**AN ORDINANCE GRANTING A SITE PLAN AMENDMENT FOR BELL WORKS
EAST GARAGE RENOVATIONS FOR THE PROPERTY LOCATED AT
2000 CENTER DRIVE, HOFFMAN ESTATES, ILLINOIS**

PROJECT NUMBER: 2021-007P
PROJECT NAME: 2000 Center Drive - Bell Works East Garage Renovations
ADDRESS/LOCATION: 2000 Center Drive
OWNER / PETITIONER: Hoffman Estates Acquisitions LLC
REQUEST: Site Plan Amendment for east garage renovations
ZONING / LAND USE: CMU Commercial Mixed Use, Bell Works mixed use campus
PZC MEETING DATE: May 19, 2021
PZC RECOMMENDATION: **APPROVAL** (8 Ayes, 0 Nays, 3 Absent)
VILLAGE BOARD MEETING DATE: May 24, 2021
STAFF ASSIGNED: Kevin Anderson, Associate Planner

PROJECT NUMBER: 2021-007P
PROJECT NAME: 2000 Center Drive - Bell Works East Garage Renovations
ADDRESS/LOCATION: 2000 Center Drive
PROPERTY SIZE: +/-150 acres
OWNER / PETITIONER: Hoffman Estates Acquisitions LLC
REQUEST: Site Plan Amendment
PUBLIC HEARING: No
ZONING / LAND USE: CMU Commercial Mixed Use, Bell Works mixed use campus
ADJACENT PROPERTIES: NORTH: M-2 Manufacturing, industrial building and vacant land
SOUTH: O-3 Office, Central Road and I-90 right-of-way
EAST: FP Forest Preserve, Huntington Blvd. right-of-way
WEST: M-2 Manufa

Project Name: **BEIL WORKS CHICAGO-BWC EAST DRIVE**
 Location: **2000 A.T.T CENTER DR, HOFFMAN ESTATES, IL**

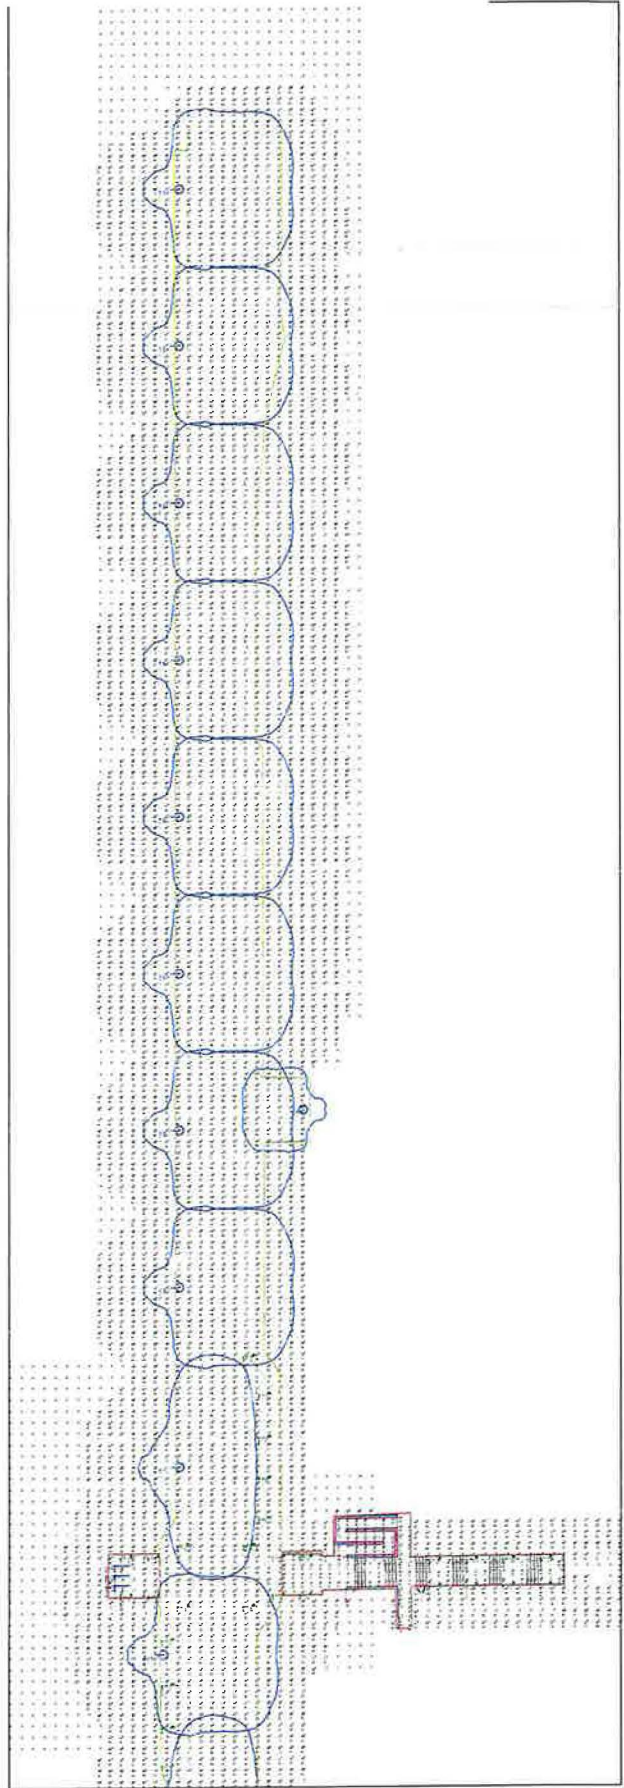
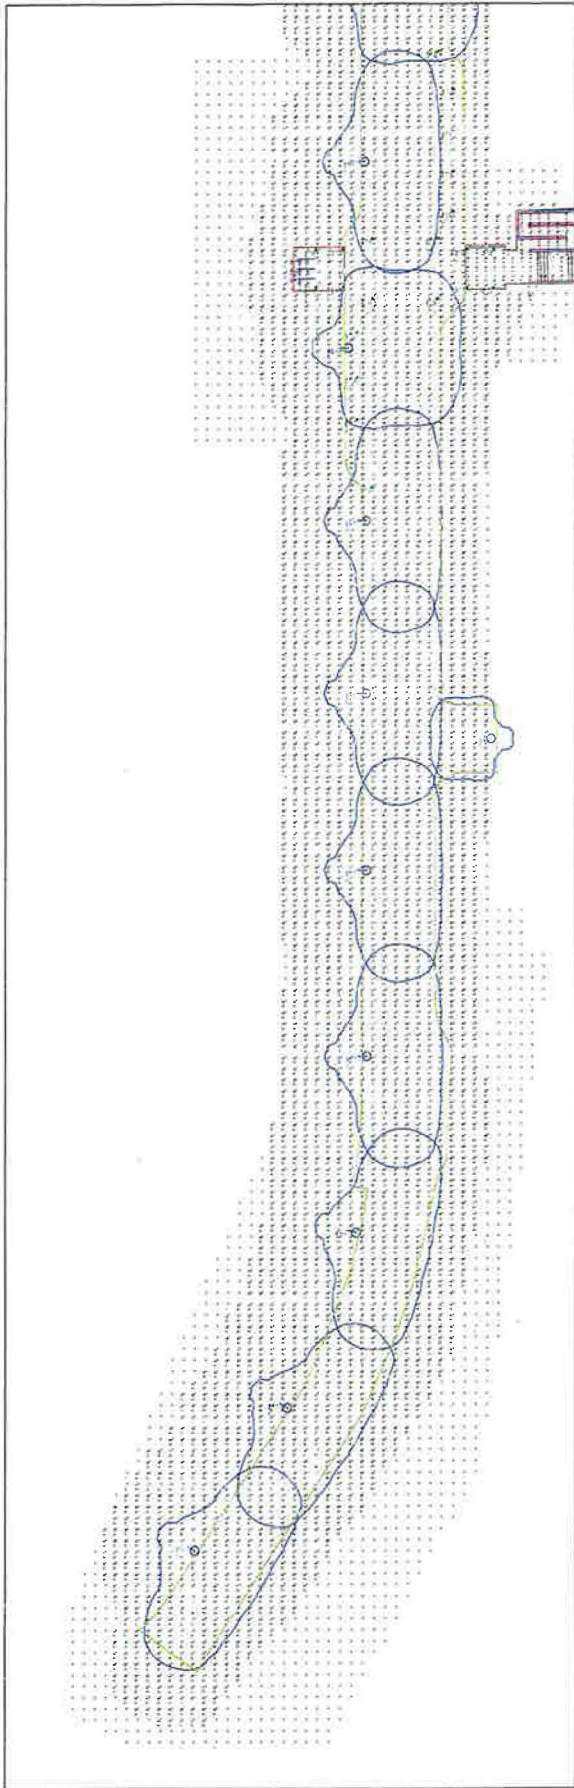
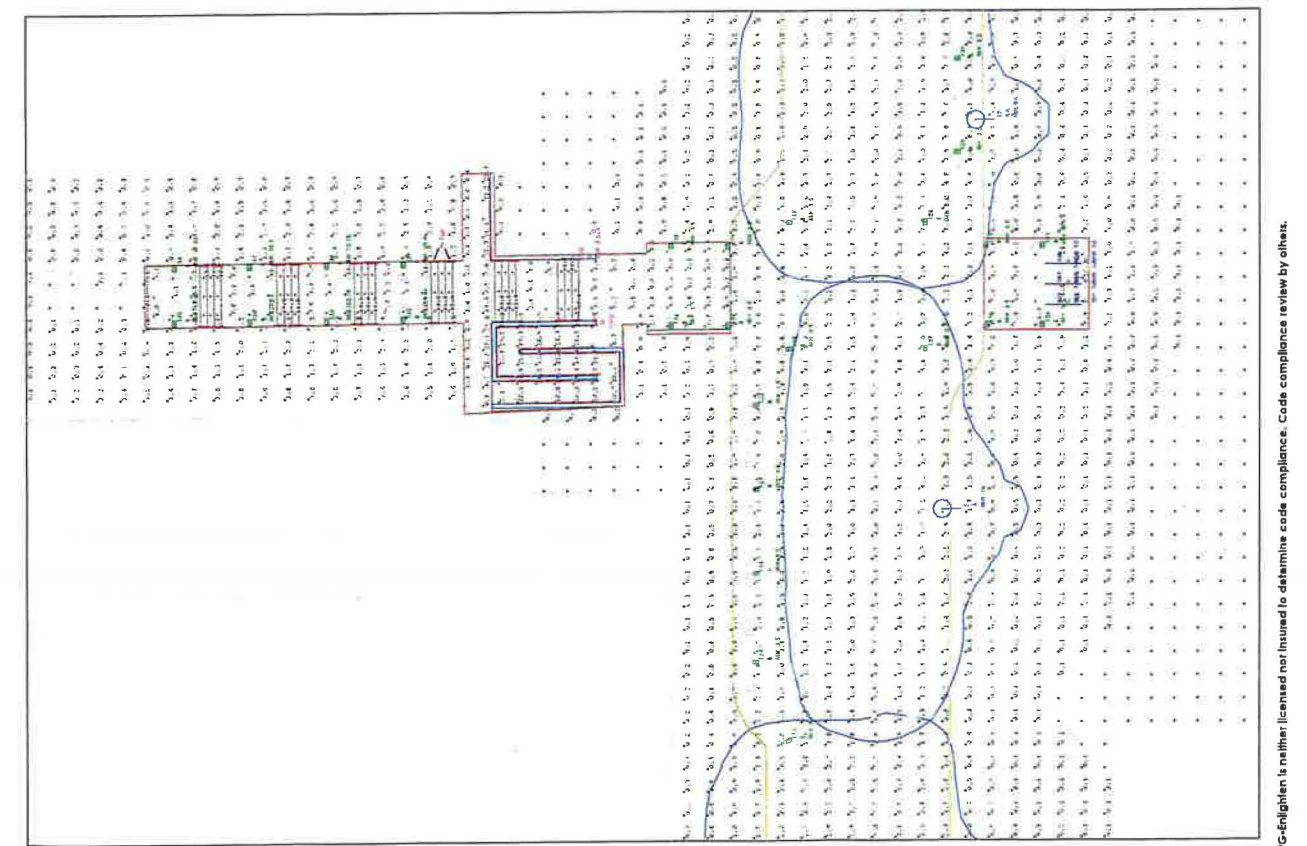
Zone 1 on the photometric plan. IES recommends a MAX:MIN ratio of 15:1 for exterior conditions for Basic Enhanced Security and 20:1 for Basic. The photometric calculations show uniform light spread and is compliant with the recommendations of IES.

Zone 3 on the photometric plan. IES recommends an AVG:MIN ratio of 2:1 for exterior building entries. The plans show 3:1, which is still a low ratio. The MAX:MIN is also fairly low and the photometric calculations show uniform light spread. IES recommends a horizontal target of 1 footcandle and a vertical target of .6 footcandles. The plans show an average of 14 fc at the garage entrance. The provided illuminance exceeds the recommendation by IES and is acceptable. (Taken from Table 22.2 Outdoor Building Entries, Canopied Entries/Exits - 10th Edition Lighting Handbook)

Zone 2 on the photometric plan. IES recommends an AVG:MIN ratio of 5:1 for exterior ramps. The AVE:MIN ratio of the ramps is 12:1. This is much higher than recommended by IES, however, the photometric calculations show adequate illuminance on the ramp areas. It is possible that this ratio may lower if taller pedestrian light fixtures are used in lieu of bollards. IES recommends a horizontal target of .4 footcandles and a vertical target of .2 footcandles. The plans show an average of 9 footcandles for stairs and ramps. (Taken from Table 34.2 Centers, Outdoors, Ramps, Stairs, Steps – 10th Edition Lighting Handbook)

Zone 2 on the photometric plan. IES recommends an AVG:MIN ratio of 5:1 for exterior stairs. The AVE:MIN ratio of the stairs is 90:1 and the MAX:MIN is 323:1, which is exceptionally high. The illumination on the stairs is not uniform and should be re-evaluated. The values at the center of the stairs are much lower than the values at the edges and this may cause an individual's eye not to adapt properly. IES recommends a horizontal target of .4 footcandles and a vertical target of .2 footcandles. The plans show an average of 9 footcandles for stairs and ramps. (Taken from Table 34.2 Centers, Outdoors, Ramps, Stairs, Steps – 10th Edition Lighting Handbook)

Zone 2 on the photometric plan. IES recommends an AVG:MIN ratio of 2:1 for the pedestrian garage entry. The AVE:MIN ratio at the garage entry is 40:1. This would likely be alleviated by the addition of a pedestrian light fixture in the space between the covered area and where the stairs begin. IES recommends a horizontal target of 1 footcandle and a vertical target of .6 footcandles. The plans show an average of 2.5 footcandles at the garage entry. (Taken from Table 22.2 Outdoor Building Entries, Non-Covered Entries/Exits - 10th Edition Lighting Handbook)

Zone 2 on the photometric plan. IES recommends an AVE:MIN ratio of 3:1, horizontal target of .4 footcandles and vertical target of .1 footcandles for the pedestrian walkways. PG Enlighten should separate the walkways from Zone 2 into its own zone(s) and recalculate. (Taken from Table 22.2 Outdoor Building Entries, Paths to Curbs - 10th Edition Lighting Handbook)

In conclusion, the main focus of concern is the stairs. The handrail lights on either side are causing a dark strip up the steps and the use of bollards on the landings do not add sufficient light to substitute. Bollards also cause hot spots just below the fixture and the center of the stair landings have much less light. The use of a taller light fixture should allow the ratios to lower significantly. PG Enlighten should recalculate using 6' pedestrian light fixtures in lieu of bollards in order to reduce AVE:MIN ratios for stairs as well as the area between the covered walkway and stairs leading to garage. Also, separate Zone 2 into multiple zones for more accurate readings.

3. Prior to issuing a certificate of occupancy for the east garage, the following items must be addressed:
 - a. Revised lighting and photometric plans in accordance with the Village's lighting consultant review letter shall be submitted and approved by Village staff.
